SEPA Cover Memorandum: Planning

To: Karla Boughton, SEPA Responsible Official
From: Marla S. Powers | Associate Planner
Subject: SEPA DETERMINATION | Port of Poulsbo Breakwater Replacement/Marina Expansion | File No. P-08-04-20-01 & P-08-04-20-02 Respectively
Date: March 23, 2021

See Excavation & Debris Removal from 60% Breakwater Design Drawings Sheets C3 to C6 shown below illustrate the location of the excavation and debris removal in detail.

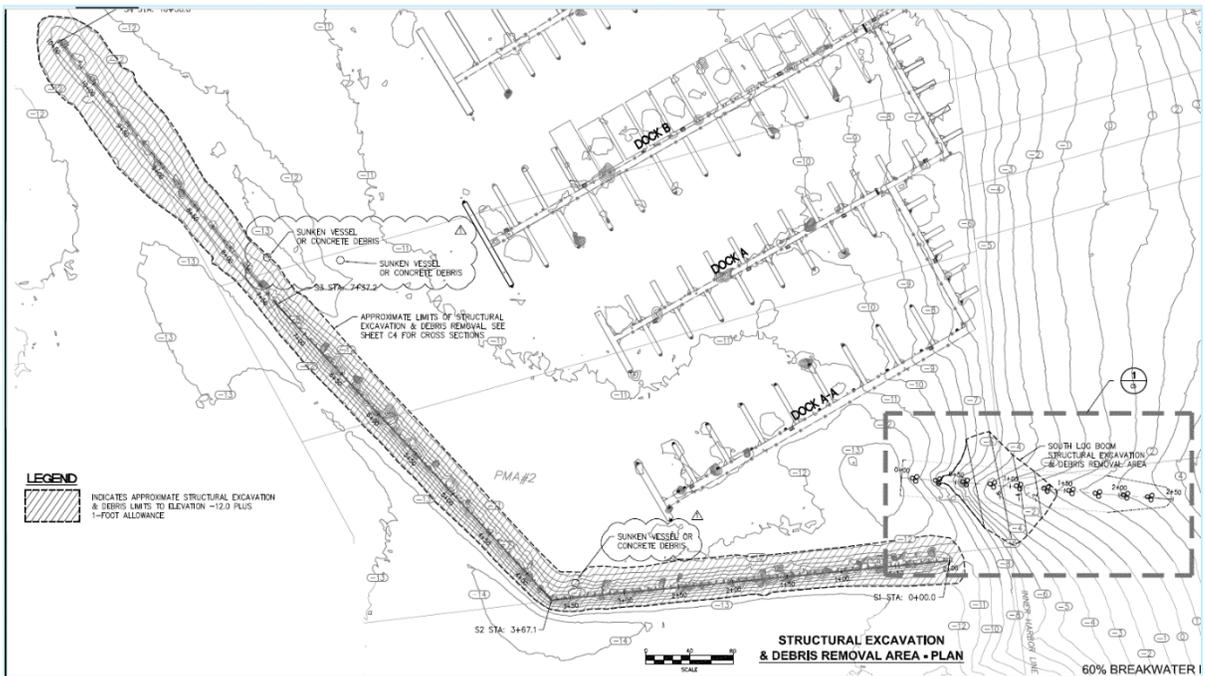
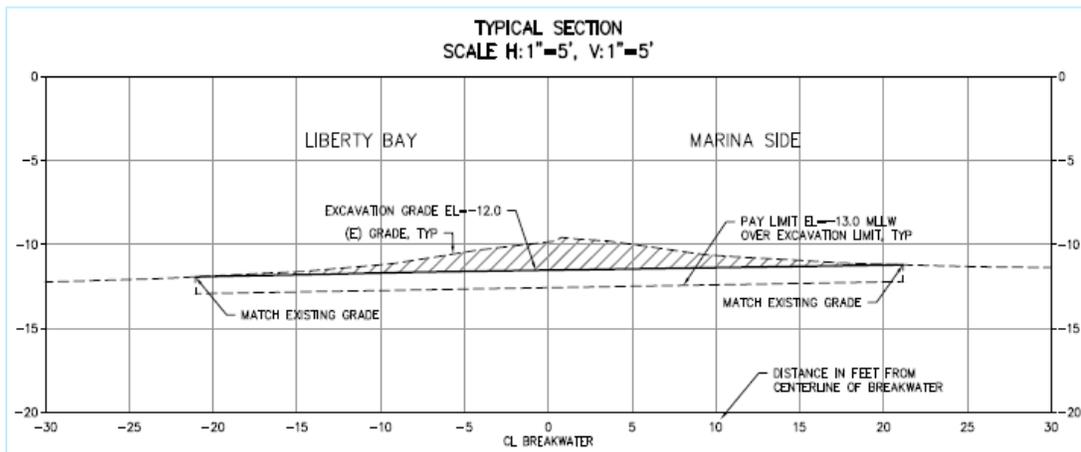
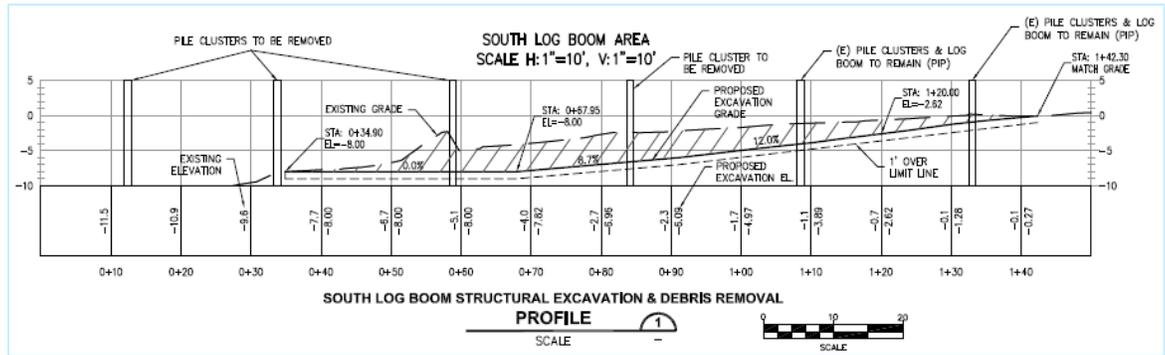
Staff Comment: The SEPA checklist states that "...2,165 cubic yards of scour protection rock and anthropogenic debris will be removed from around the base of the existing breakwater sections. Approximately 1,085 cubic yards of sediment and creosote-timber debris will be removed around the base of the north and south log booms."

Neither of these numbers are found in the BE or the Mitigation Plan, nor was it included in the Peer Review Memorandum from Anchor QEA, LLC. However, both the Anchor QEA, LLC and Mitigation Plan include the same numbers as follow for the amount of sedimentation

and debris removal. The city considers these the project removal amounts (Table 1, Mitigation Plan):

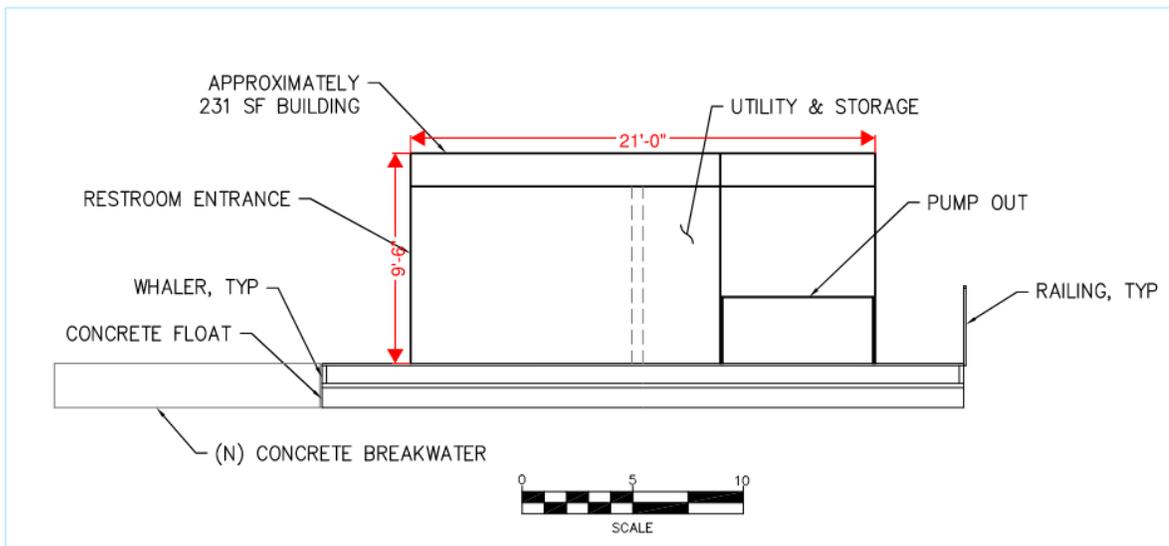
c. Staff Comment: The floating restroom details provided in the Memo: Marina Expansion Demand Dated July 27, 2020 states that the floating restroom is intended to serve the transient moorage visitors. It will be a prefabricated “vault” style restroom that will be pumped out by boat and will not require a new connection to the City sewer system. Some details are included in the 60% Design Drawings on Sheet C10 but they do not provide color or materials to show the aesthetics.

The above diagram from Sheet C10 shows that the height of the restroom will be approximately 9’6” and that the size will be approximately 14’ x 11’ or approximately 154 ft², and that the structure will be placed on a new float that is approximately 29’ x 17’ or 493 ft².
